# PENSKE CENTER

## LOT 1, BLOCK 1, PENSKE SUBDIVISION FILING NO. 1

### CITY OF AURORA, COLORADO

# SITE PLAN

SITE LIGHT DETAIL  
NOT TO SCALE

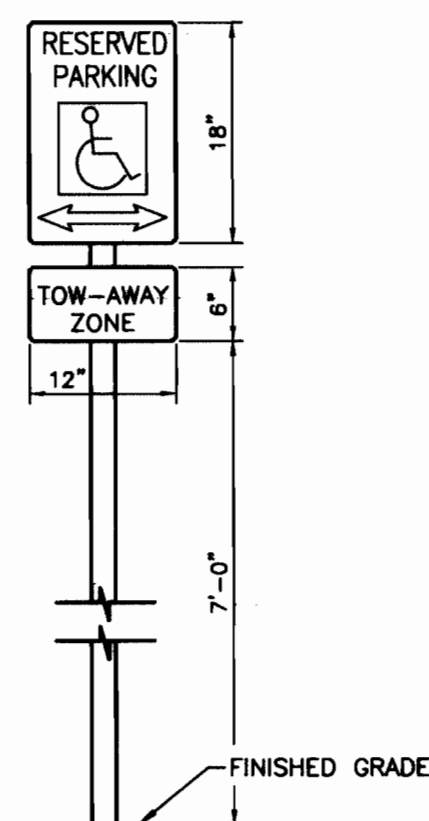
Please include a photometric plan sheet. It must show and label the location of the internal site accessible route. Provide a minimum of 1 foot-candle of lighting within the accessible route.

KH: A photometric plan has been included with this submittal.

REVISIONS	
11-17-00	BID ISSUE
4-23-02	
△	
△	
△	
DATE	ISSUED FOR
8-25-00	PERMIT SUBMITTAL
EXTERIOR ELEVATIONS

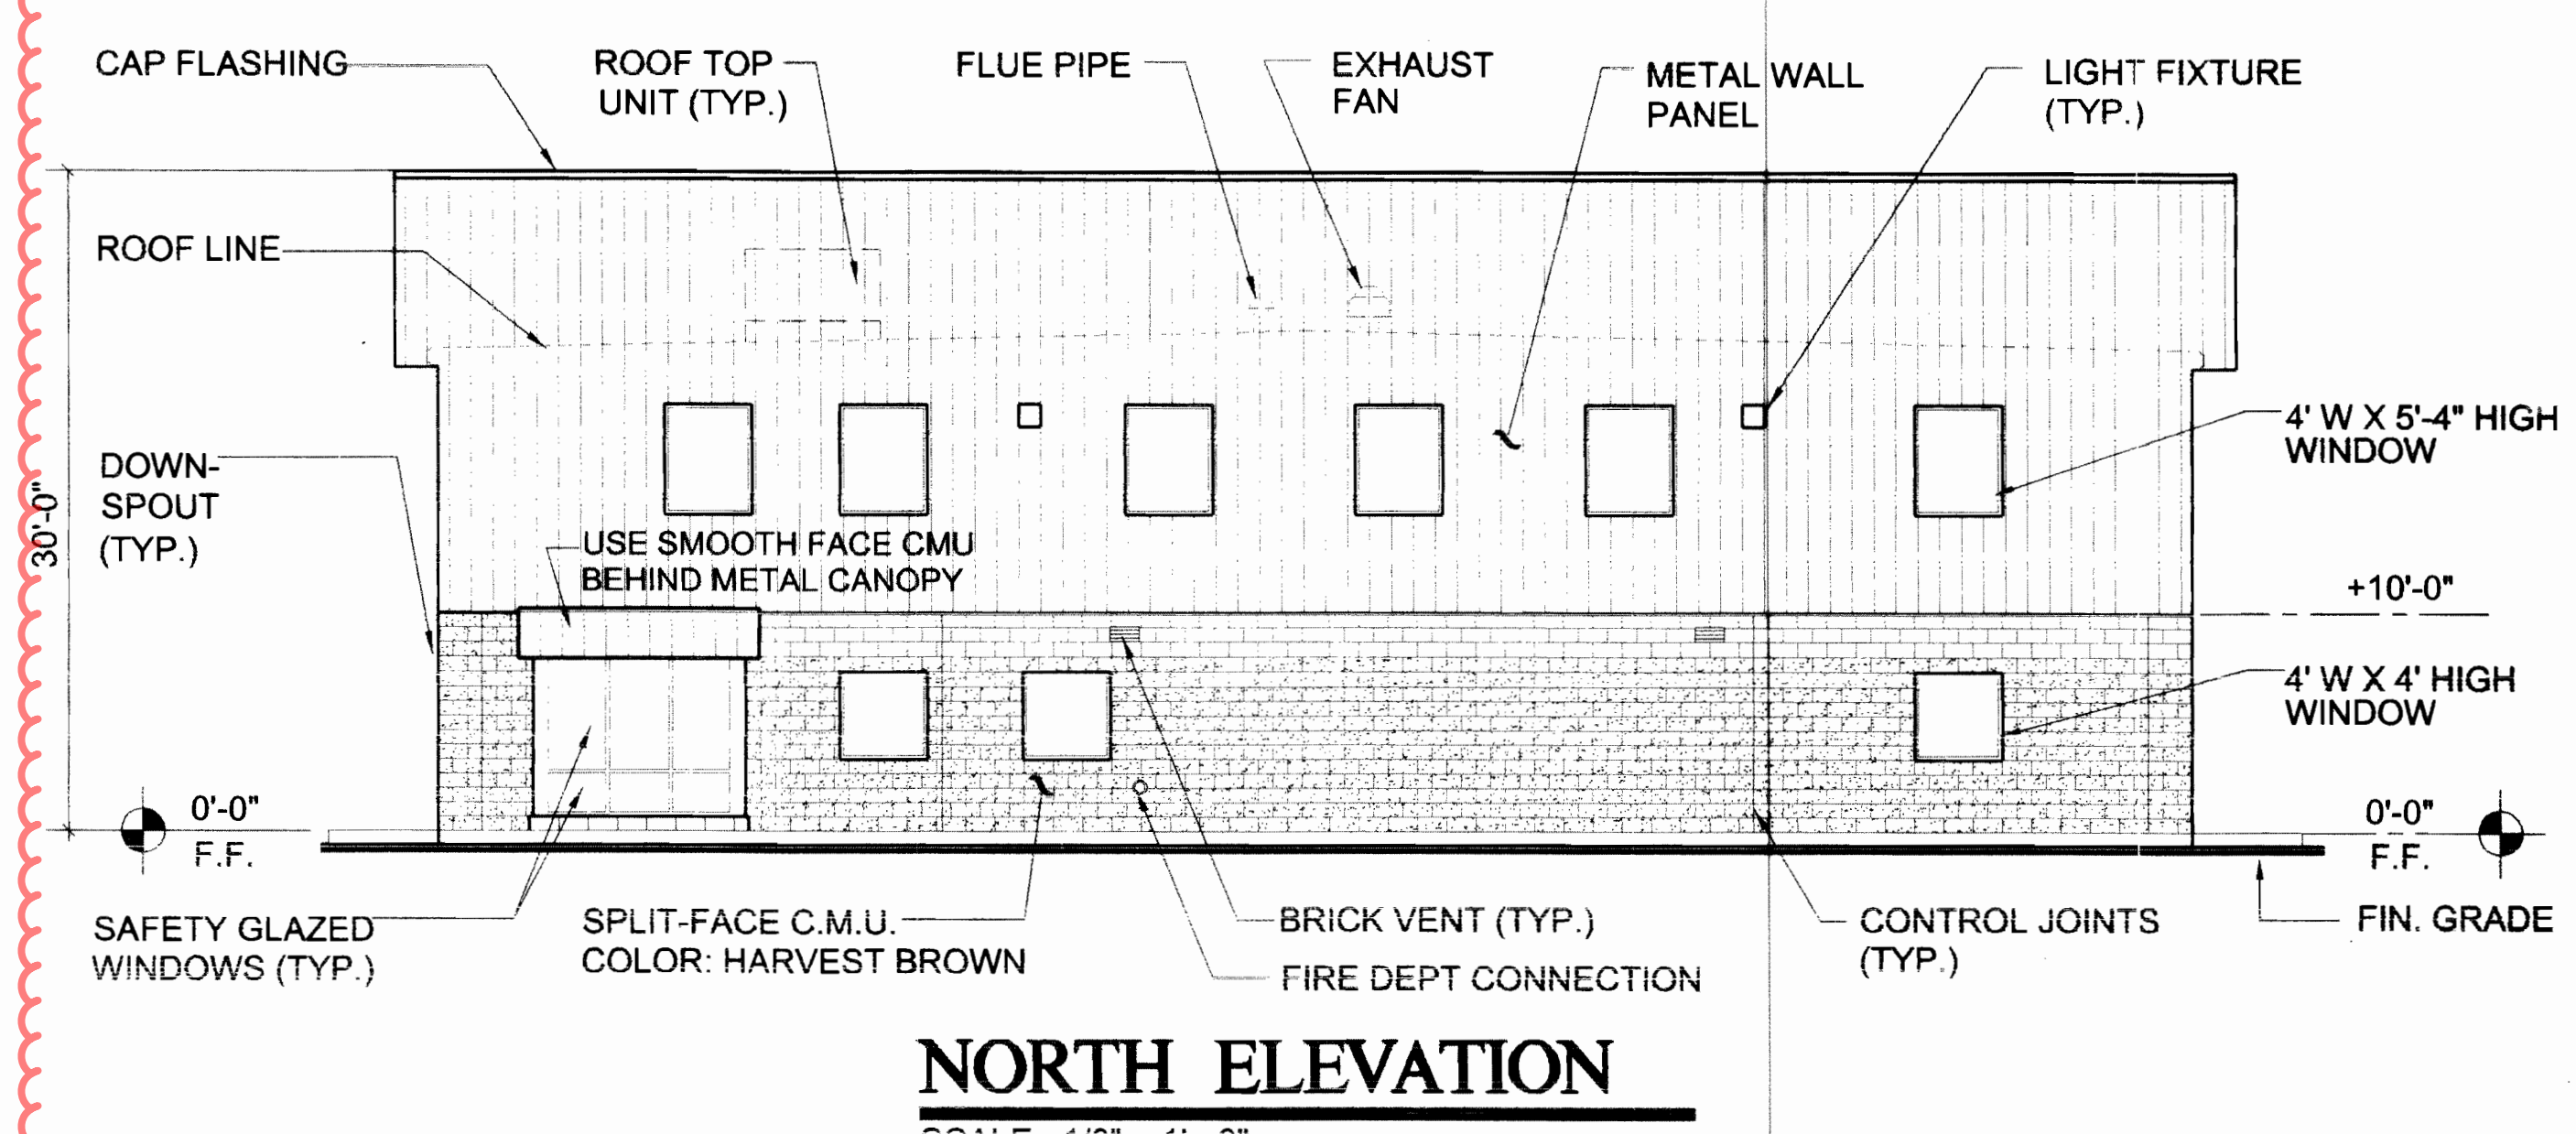
Update the elevation sheets to:  
 - Show symbol and label for the FDC.  
 - Show symbol and label for the Knox Box.  
 - Show location of Riser Room exterior door.

KH: These plans are part of the original site plan. The FDC, Knox Box, and Riser Room exterior door are shown on the updated elevation sheets showing the proposed building expansion.

### 3 ACCESSIBLE PARKING SIGN

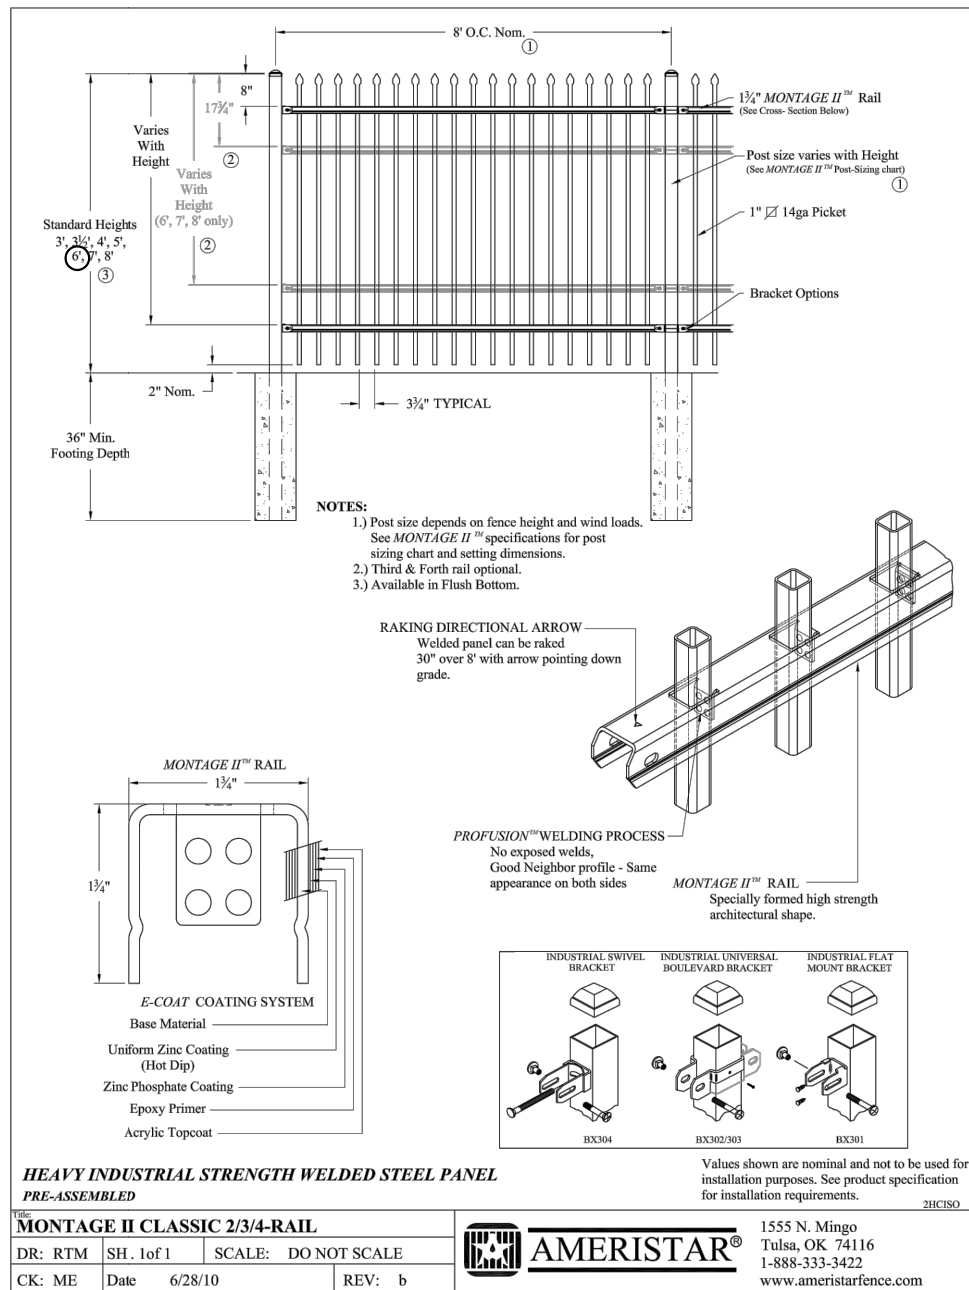
Provide gate details. See example. All gates must be named identically across all sheets. TYP

KH: Gate details have been provided on the elevation sheets.

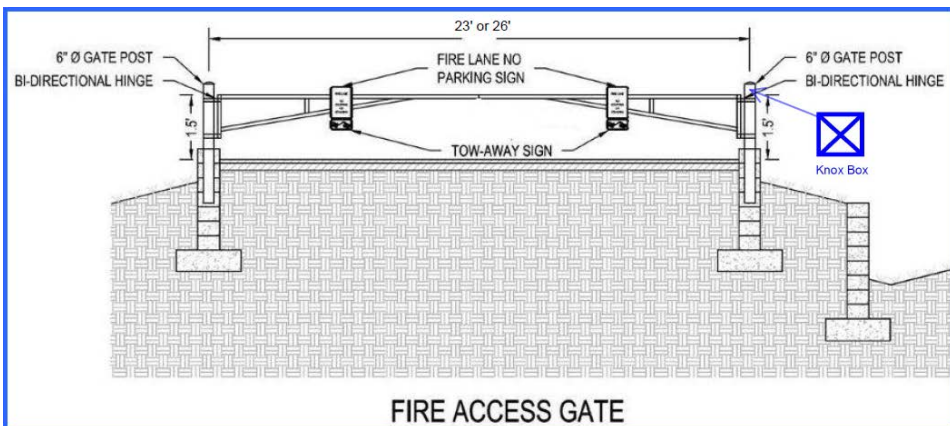
Gating or barricade systems must be shown on the site plan in the following manner:

- The minimum gate width shall be 23 feet and shall not encroach into the fire lane easement.
  - Gating and barricade systems must be located a minimum of 35 ft. back from the adjacent street flow line.
- Label the type of gating or barricade system being installed on the site plan using one of the following examples:
- 23' Automatic Sliding Gate with approved Siren Operated System, Knox Key Switch and Manual Release.
  - 23' Manual Swinging Gate with Approved Knox Hardware.
  - 23' Manual Sliding Gate with Approved Knox Hardware.
  - 23' Electrical Sliding Gate with Approved Knox Hardware.

KH: A gate detail has been included on the elevations sheet.

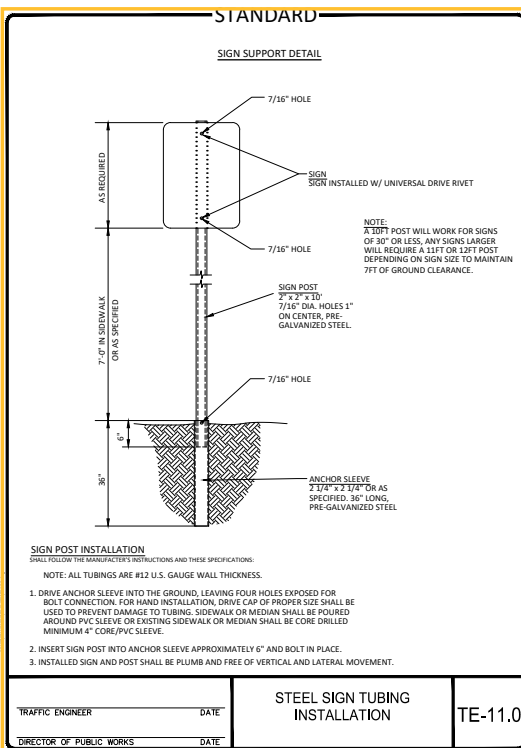
Provide STOP sign detail (R1-1) with size and reference COA's TE-11 sign post detail

KH: Stop sign detail with COA reference has been added.
